**RESOLUTION ACCEPTING  
THE REVISED FEIS AS COMPLETE  
FOR THE COSTCO WHOLESALE CLUB**

**DATE OF RESOLUTION: OCTOBER 6, 2014**

**RESOLUTION NUMBER: #14-23**

Site Plan Site Plan

FEIS Site Plan Exhibit 2  
**Parking Aisle Intersections**  
 Scale: 1"=100'

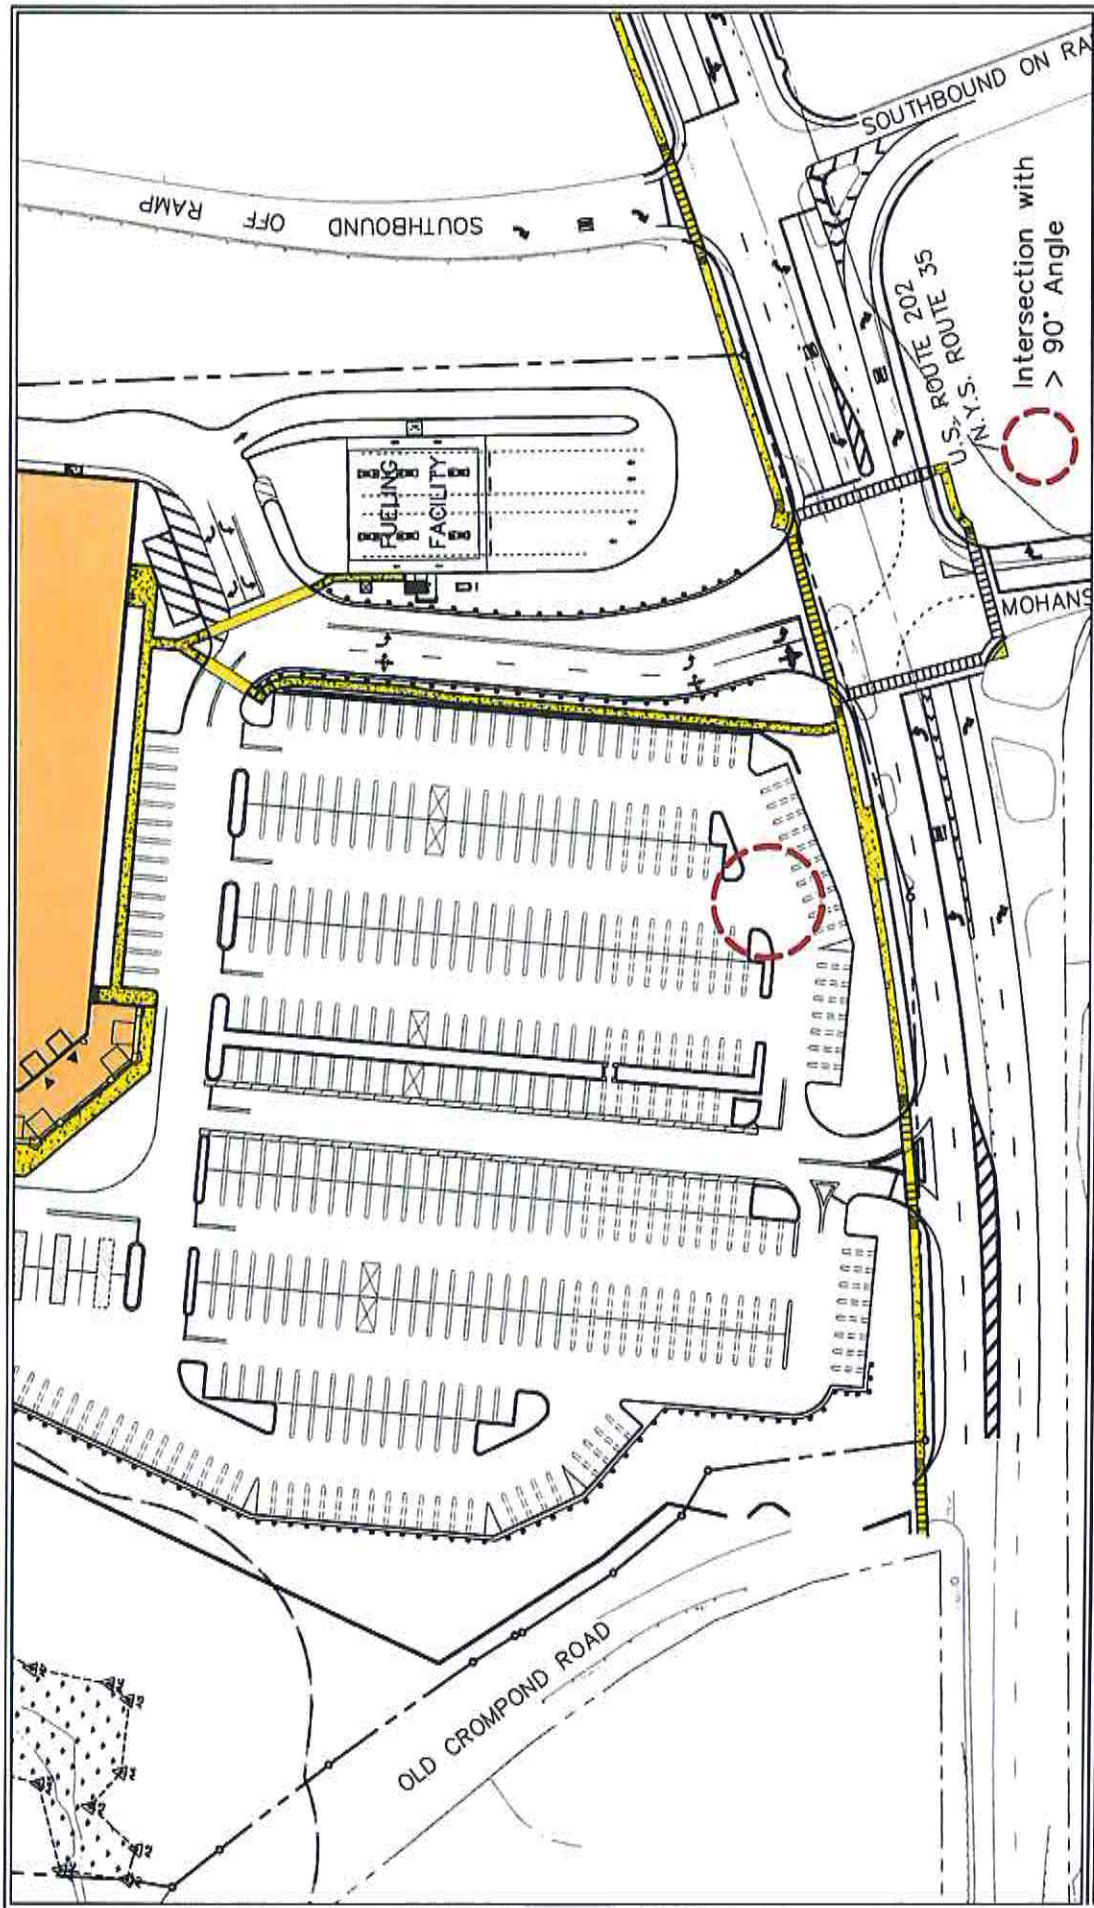
- Sight line issues occur when there are visual obstructions (trees, guard rails, signs, etc.) and vertical and horizontal geometry problems. There are locations on the Costco site where sight line angles require severe body turns in order for drivers to see oncoming vehicles. This can occur at 90 degree intersections where vehicles are approaching the intersection immediately after a turn as at the secondary site access.

Design criteria for parking lots are less stringent than the standards required for public streets and highways. Roadway design standards vary depending upon such criteria as traffic volume and speed limit. Roadways having lower speed limits and traffic volumes are not required to be designed to the same standard as, for example, arterial roadways or highways.

Since parking lots are low speed environments (typically 15 mph), divergence from highway and street standards is not unusual. Therefore, it is not uncommon for intersection sight line angles in parking areas to be greater than 90 degrees. Thus, the Applicant asserts that it is acceptable for parking aisle intersections to diverge from the ideal public street design standard resulting in angles greater than 90 degrees. Refer to FEIS Site Plan Exhibit 2.

In response to public comments, the Applicant's engineer has reviewed the site plan submitted with the DEIS and modified several interior intersections to soften intersection angles. Compare DEIS Site Plan, Introductory Exhibit 1 to FEIS Site Plan, Introductory Exhibit 2. Also refer to FEIS Site Plan Response 2e. Regarding potential restriction of sight, due to physical obstruction from proposed landscaping, the landscape maintenance plan will include pruning of low tree limbs and trimming of shrubs to prevent potential visual impairment.

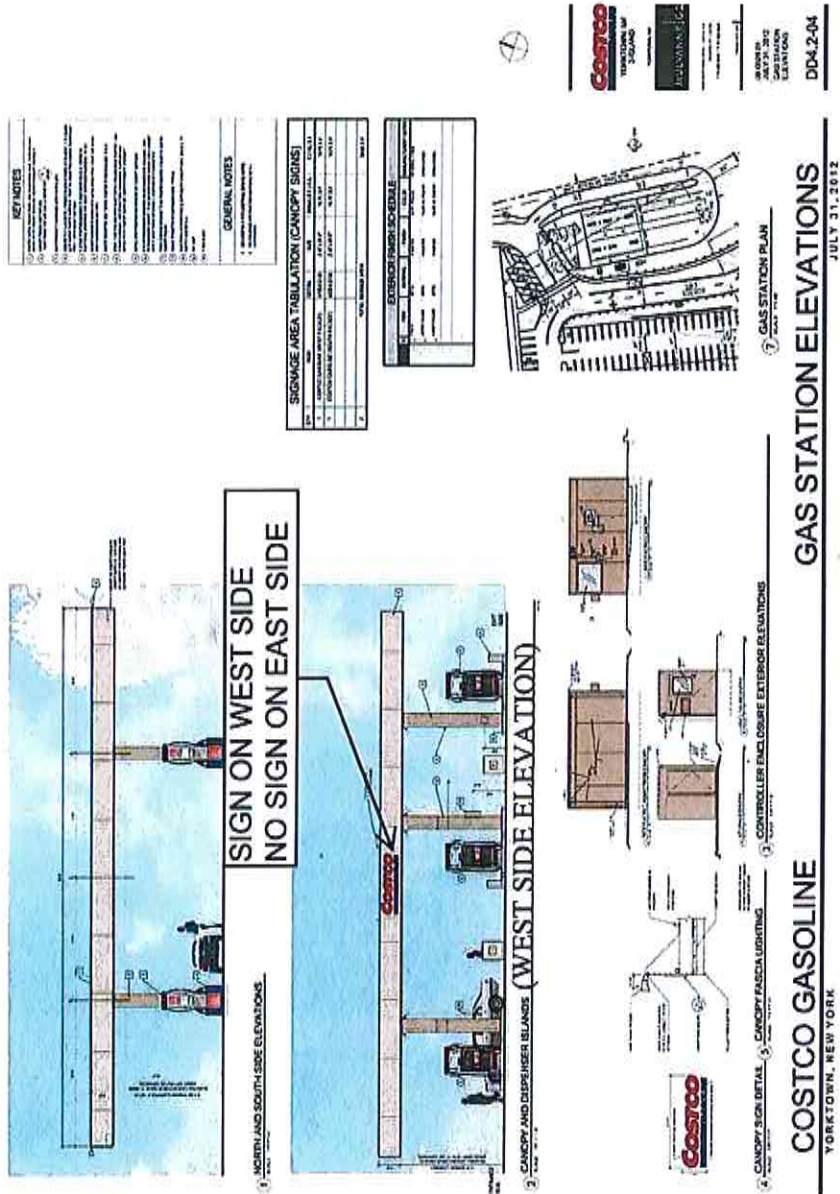
- Part of the development is in the wetland buffer. Transportation infrastructure and other infrastructure should be removed from the wetland buffers.

Wetland A, as determined by the Applicant's wetland consultant, is a highly functional wetland and its 100 foot buffer is largely wooded. The Proposed Action proposes no impervious surfaces within the wetland or its buffer. In response to concerns raised in public comments, the Applicant proposes to reduce grading impacts to the buffer by diminishing the proposed earth embankment west of the parking area. The embankment will be reduced by constructing a vertical retaining wall. This modification to the DEIS Site Plan will result in maintaining significantly more of the wooded buffer to Wetland A. The disturbance to the natural wooded buffer under the DEIS Site Plan was 1.05 acres. When accounting for a 10-foot construction corridor to be cleared at the toe of the slope, the disturbance would have been 1.26 acres. Under the FEIS Site Plan, with consideration of a 10 foot wide construction corridor to construct the wall, the disturbance will be 0.5 acres, or roughly 60% less than for the DEIS Site Plan. The result will be retaining around  $\frac{3}{4}$  of an acre more of the wooded buffer. Refer to FEIS III.G Introductory Summary Response and FEIS Responses in Section III.F.

Wetland B, as described in Section III.F.1 of the DEIS, is a small hydrologically isolated wetland (5,757 square feet, 0.13 acres), -having few functions and values that are typically associated with wetlands. (Refer to FEIS Responses III.F 5, 16, 30 and 36.) The portion of its buffer located on the Project Site is largely disturbed, consisting of young forested area including nonnative invasive species and maintained lawn areas. Since, by comparison, Wetland A is significantly more valuable than Wetland B, the Applicant's development strategy was to place the proposed development to the eastern portion of the Site, thereby minimizing potential impacts to Wetland A buffer.

The Proposed Action includes constructing impervious area within the south and west buffers to Wetland B. The west and south portions of the buffer that will be disturbed by the Proposed Action do not presently drain toward Wetland B and, therefore, do not provide wetland protection in the form of runoff pretreatment. Although portions of the Wetland B buffer will be paved, there will be no loss of infiltration, since

**FEIS Site Plan Exhibit 8a(2a)**

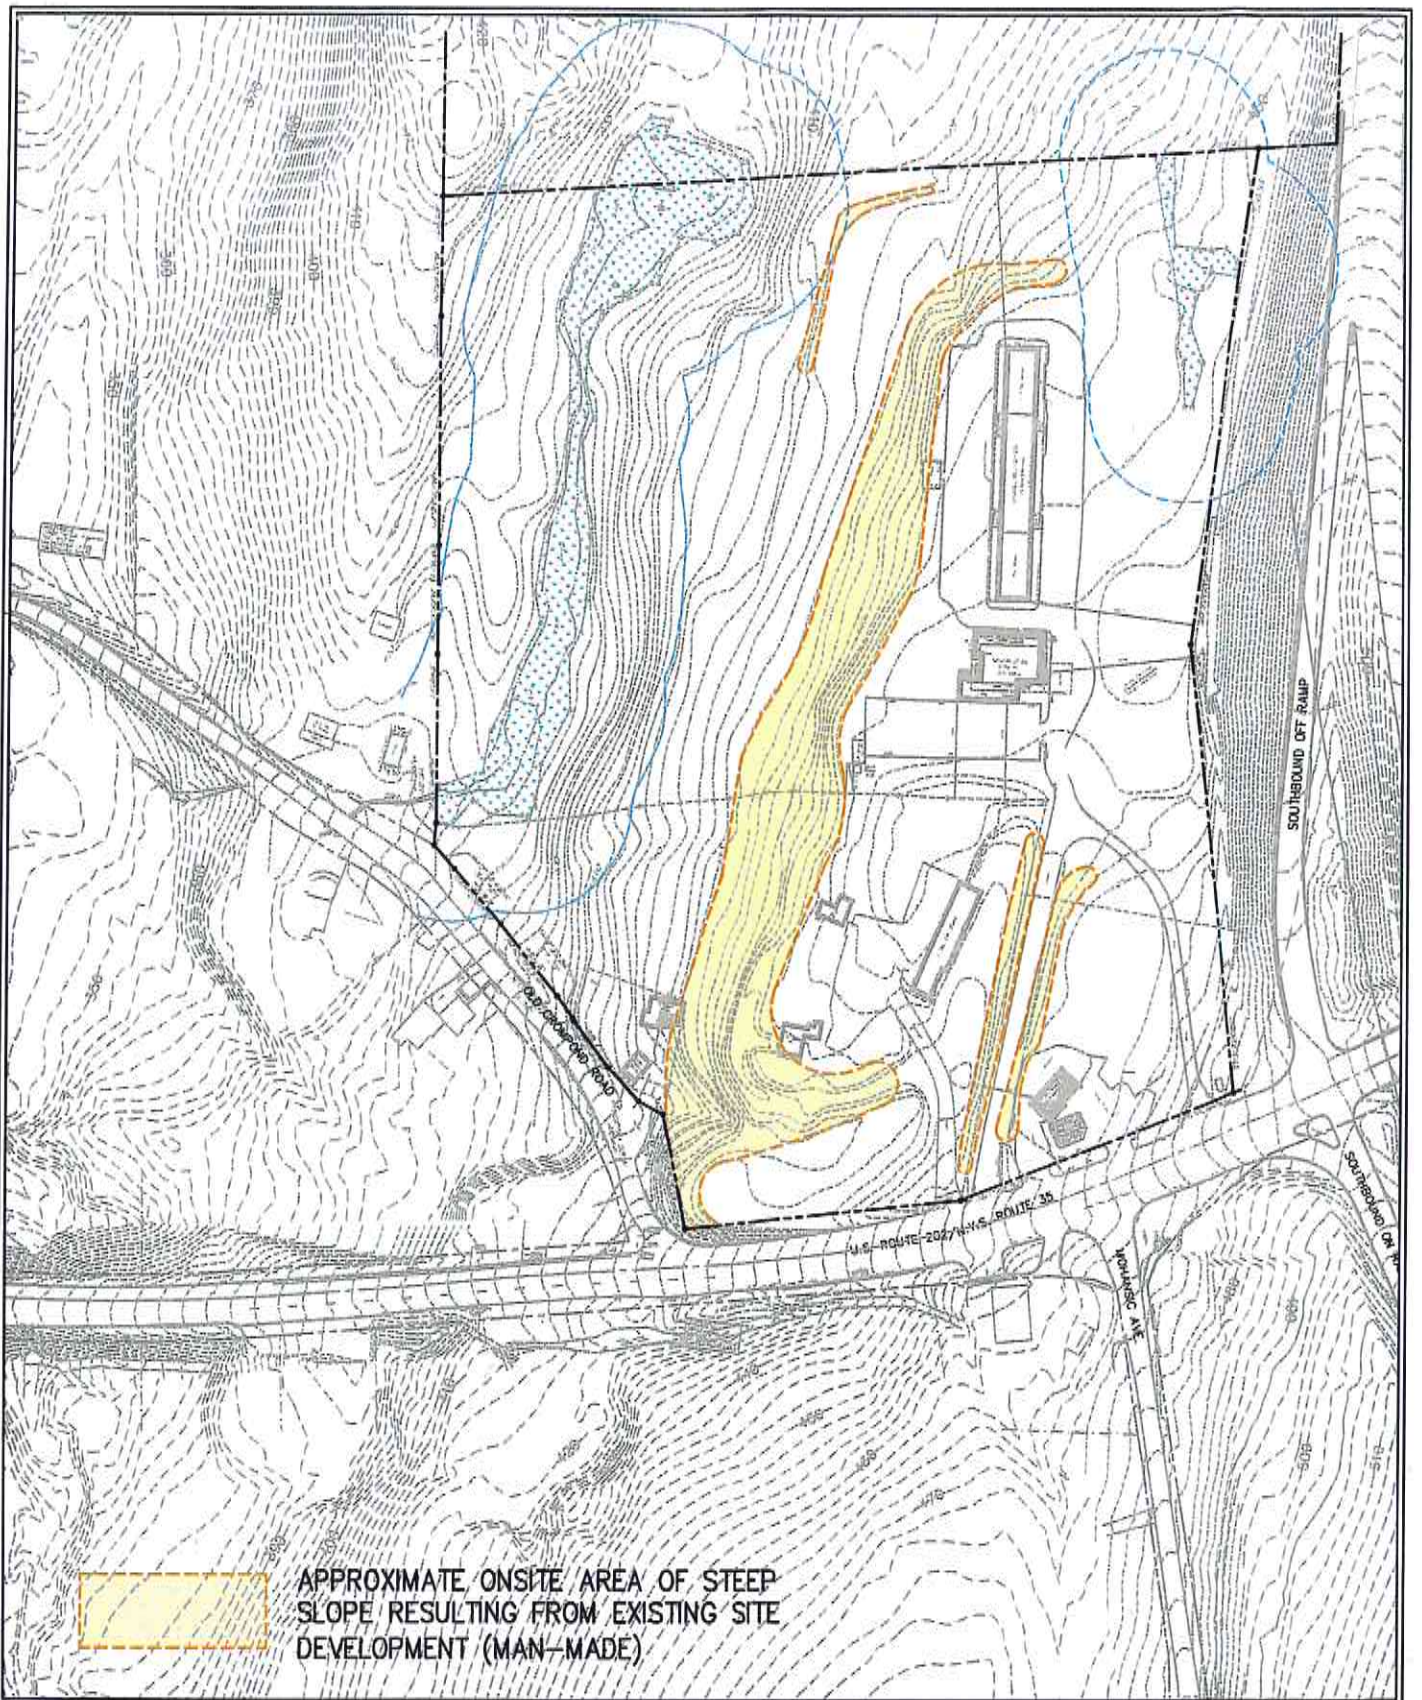
vegetated areas. Maintenance activities on slopes this steep will present health and safety hazards for the workers involved with ordinary site maintenance. This area of the site should be re-designed so that no earthfill slopes are steeper than 2.5:1. If this is not desirable, vertical structural retaining walls may be necessary.

The more environmentally sensitive portions of the Site, which include Wetland A and steep slopes, are largely located on the western half of the Site. Much of the existing steep slopes around the nursery and motel parcels were formed through the cut and fill process during their construction.

As part of the planning process, consideration was taken to minimize impact to existing sensitive areas located at the western portion of the Site near and adjacent to the Wetland A buffer. As such, the Costco building was placed as far east as possible to minimize westward encroachment and minimize required earthwork.

In light of this Comment's request to avoid construction on/of steep slopes, the Applicant modified the site plan to further reduce impacts to the wooded slopes in the Wetland A buffer. FEIS Site Plan modifications include construction of retaining walls and flattening of proposed embankments in areas in or adjacent to Wetland A buffer. Refer to FEIS Site Plan Responses 2a, Site Plan 6 and III.G Introductory Summary Response. The FEIS Site Plan will flatten the westerly embankment slopes from 1.5:1 to a combination of 3:1 and 2:1. The embankment will slope away from the parking area and will be comprised of a flat section followed by sloped section varying from 3:1 to 2:1. (Refer to FEIS Site Plan Exhibit 8c and Exhibit 8a(1).

This Comment states that the DEIS Site Plan included disturbance of 0.78 acres that would occur on slopes steeper than 25 percent (refer to FEIS Site Plan Exhibit 8a(2)). The Applicant asserts that construction on such slopes within the interior of the Site (most created during construction of the existing development) is unavoidable. See FEIS Site Plan Exhibit 8a(2) and 8a(2a).) The FEIS Site Plan, however, will significantly reduce construction on slopes greater than 25 percent within the Wetland A buffer from 0.52 to 0.12 acres. See FEIS Site Plan Exhibit 8a(3).

FEIS Site Plan Exhibit 9  
**Fueling Facility Plan**  
 Scale: 1"=50'

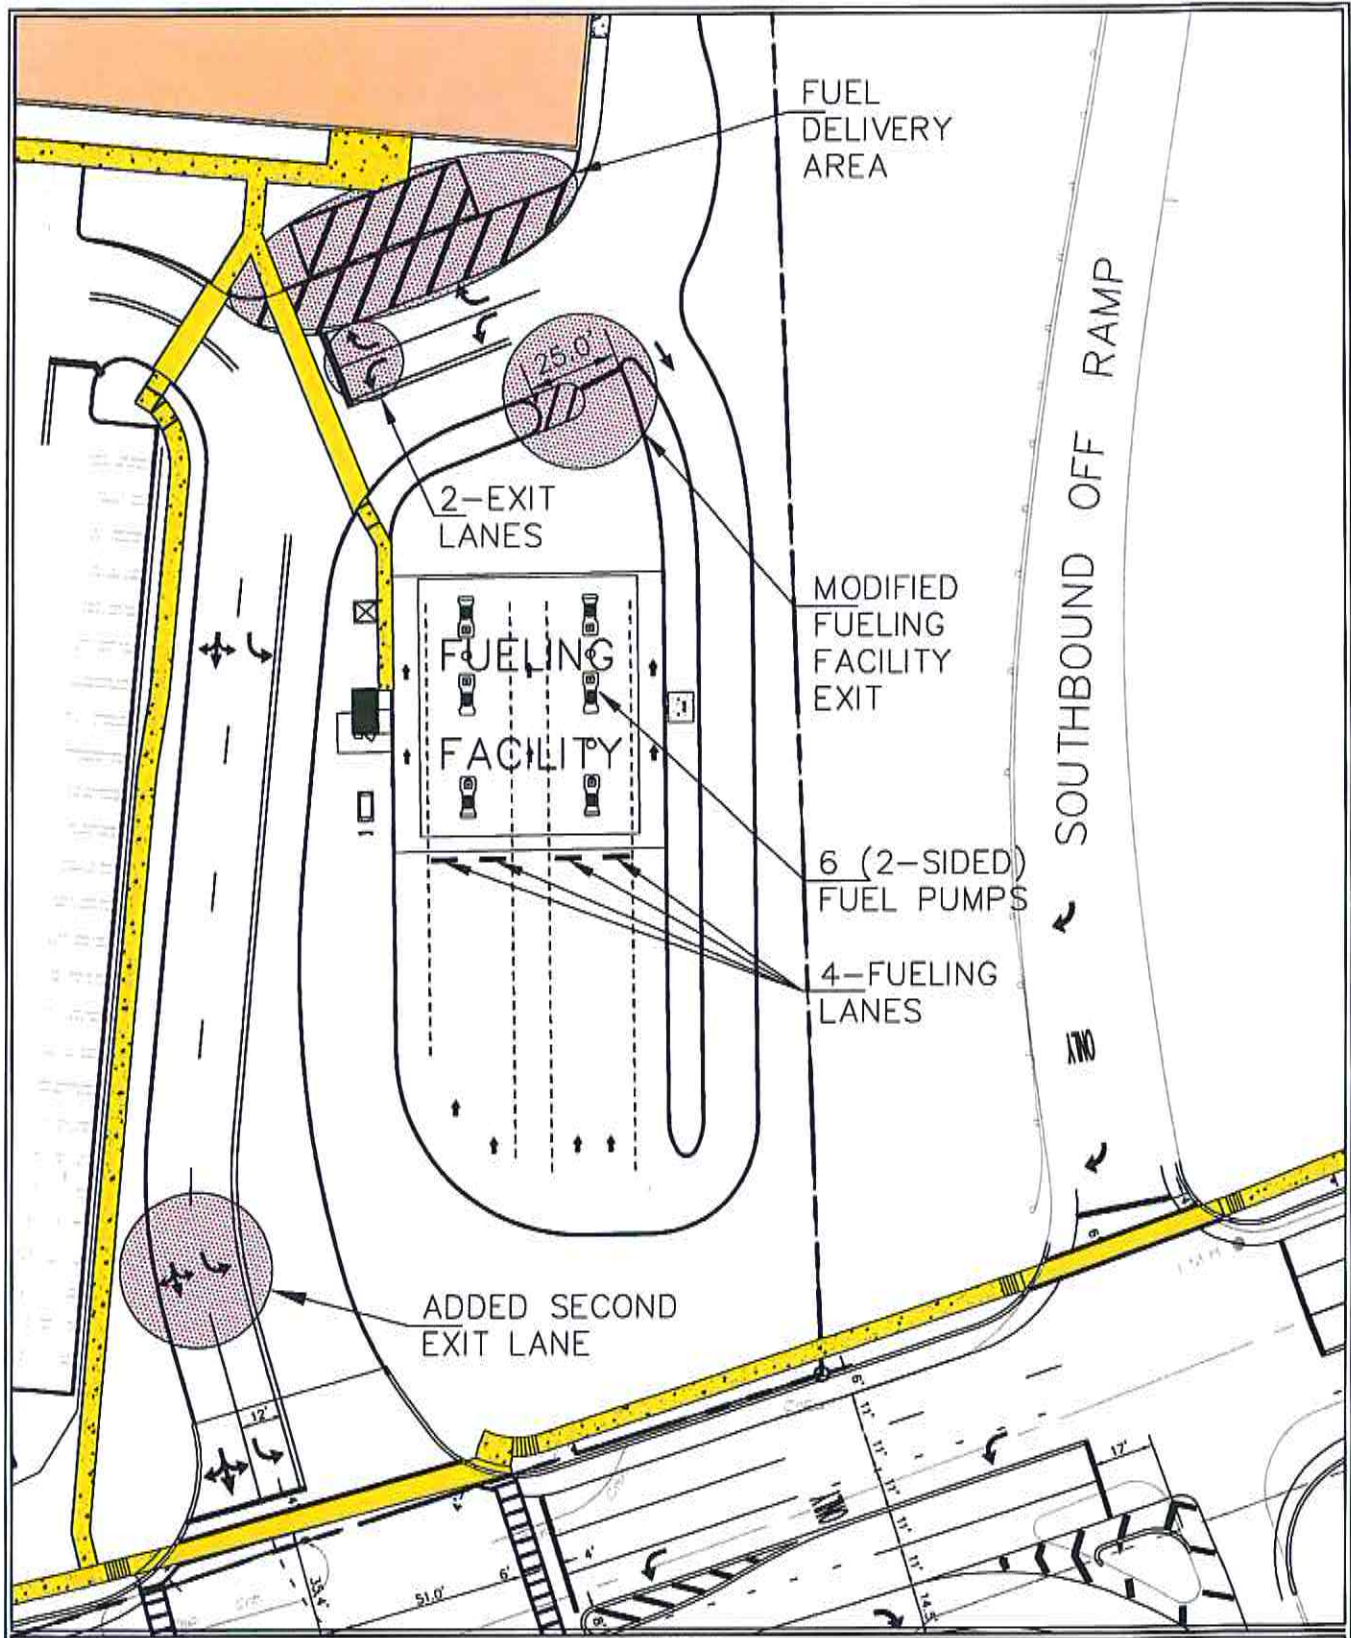
Inadequate Erosion and Sediment Controls

Missing Elements: Construction Drawing C-401 details the erosion and sediment control plans for the site. Missing from this sheet is a culvert outlet scour pad for the stormwater management pond inlet, a detailed construction phasing plan addressing temporary swales, sediment traps, and staging area details. A concrete truck washout facility for construction operations is also missing. All of these deficiencies need to be addressed in the SWPPP of the DEIS.

Missing Details: The erosion control details shown on Construction Drawing C-705 should be amended to provide the following details: rock gradation for lined channels, actual dimensions for the stabilized construction entrance, and the creation of tables that show specific site locations for energy dissipaters and water bars. Stone outlet sediment traps and water bars are not shown on Construction Drawing C-401 and should be if they are part of the proposed project. In addition, the stone/rubble gravity retaining wall explained in detail #10 on Construction Drawing C-703 does not appear to be erected at the project site. As such, this detail should be deleted. However, a detail for a concrete truck washout facility needs to be added on Construction Drawing C-705.

Highway Improvement Work: An erosion and sediment control plan needs to be developed for all the highway improvement work and offsite sanitary sewer connection construction activities that will accompany this project.

A final Construction Phasing Plan, as well as the recommended erosion and sediment control elements and details, are included in FEIS Section III.O and on the FEIS Site Plans-. For discussion regarding the Construction Phasing Plan, also refer to FEIS Response III.O 4.

Sediment and erosion control plans for the offsite highway improvements and sanitary sewer extension activities are included in FEIS Section III.O. Highway drawings are included as part of this FEIS (Appendix J).

FEIS Exhibit III.B-55  
Sight Line Section Location Plan  
AA/BB/CC/DD/EE/FF

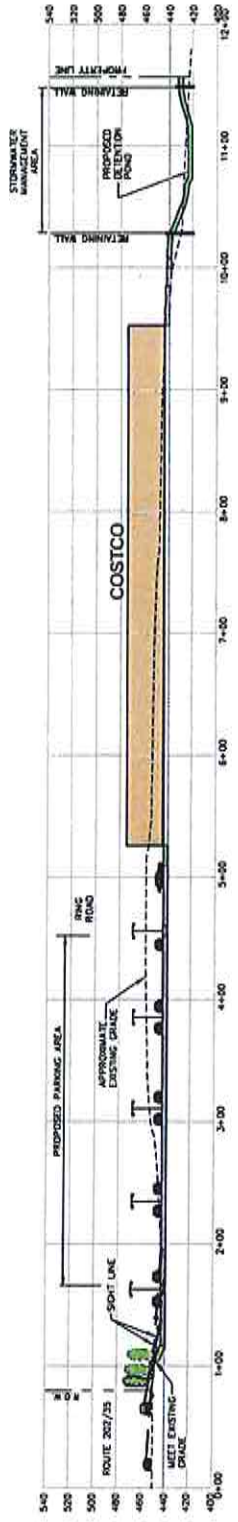
Sight line drawings do not show sight lines from the Taconic State Parkway which sits higher and has higher traffic volumes than its ramps. Drawings should clearly show existing sign restriction zones and indicate height of trees shown. Since The Taconic State Parkway is a State Scenic Byway, how is the site going to be visually buffered from the Taconic State Parkway main lanes which are higher than the ramps? The visual section shows the site and building will be visible from the Taconic State Parkway.

Sightlines from the Taconic State Parkway (TSP) are illustrated in FEIS Exhibit III.B-56. As shown in the elevation, the building and site ~~willeould~~ be visible from the parkway; however, with the dense array of proposed landscape vegetation, the view will be partially screened. The evergreen trees represented in the illustration are assumed to be 20 feet in height, which should be achieved approximately 5 years after initial planting. Also refer to FEIS Exhibits III.B-20a, III.B-41a thru III.B-46a

The extent of screening of the view from the Taconic State Parkway from newly-planted trees is dependent on several factors, including: (1) the type of trees (evergreen or deciduous) to be planted, (2) the height of the trees, (3) the density or closeness to each other of the trees to be planted, and (4) the arrangement of the trees at the time of planting.

Primarily, the screen trees will be evergreen and will therefore provide a year-round ability to screen the view from the TSP, since they do not shed their leaves at the end of the growing season. The shrubs to be planted will provide additional screening of the views from the TSP, as well as providing contrast (to a staggered row of evergreen trees), as well as color, texture and interest, including to passing cars on the southbound exit ramp.
